Access Compliance Report Public Rights-of-Way (Curb Ramps)

Main Street: CHAPMAN_AVE		Cross Street: RANCHO_SANTIAGO_BLVD		Location:	SW
ADA ID: RPAT210929124617	Ramp Type: Type 4 - Parallel	Initial Pass/Fail: Pass	Overall Compliance: No	Severity Score:	5
Codes/Mitigation Info/Possible Solution			Field Measurements/Component Compliance

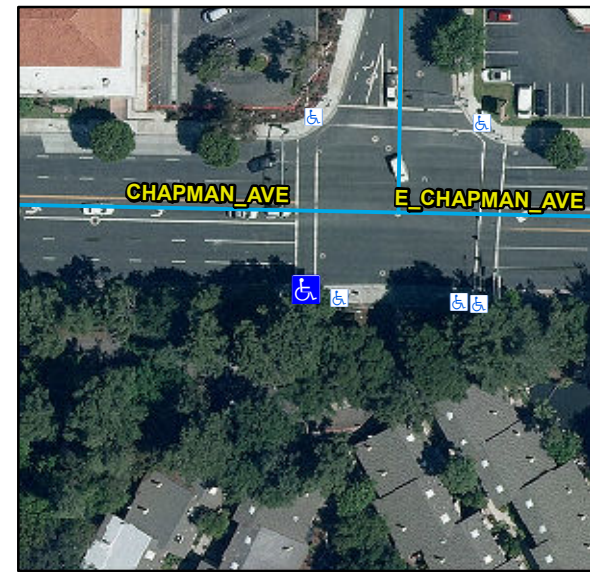
Yes	Ramp Inside Crosswalk 1	Yes	N/A	Ramp Inside Crosswalk 2	N/A
	Crossing 1 Slope (%)	4.8		Crossing 2 Slope (%)	N/A
	Crossing 1 Cross Slope (%)	1.1		Crossing 2 Cross Slope (%)	N/A
Yes	Gutter Ponding	No	Yes	Curb Slope	1.1
Yes	Gutter Lip Height (in)	0		Road Run Slope (%)	N/A
No	Gutter Run Slope (%)	7.9		Road Cross Slope (%)	N/A
Yes	Gutter Cross Slope (%)	1.7	Yes	Perpendicular Joint Present	Yes
Yes	Overall Surface Condition	Acceptable			
	Cross Gutter Present?	No		Spandrel Present?	No
	Replace Cross Gutter?	N/A		Replace Spandrel?	N/A

Remove & Replace Gutter.

R304.5.4, STD 1115
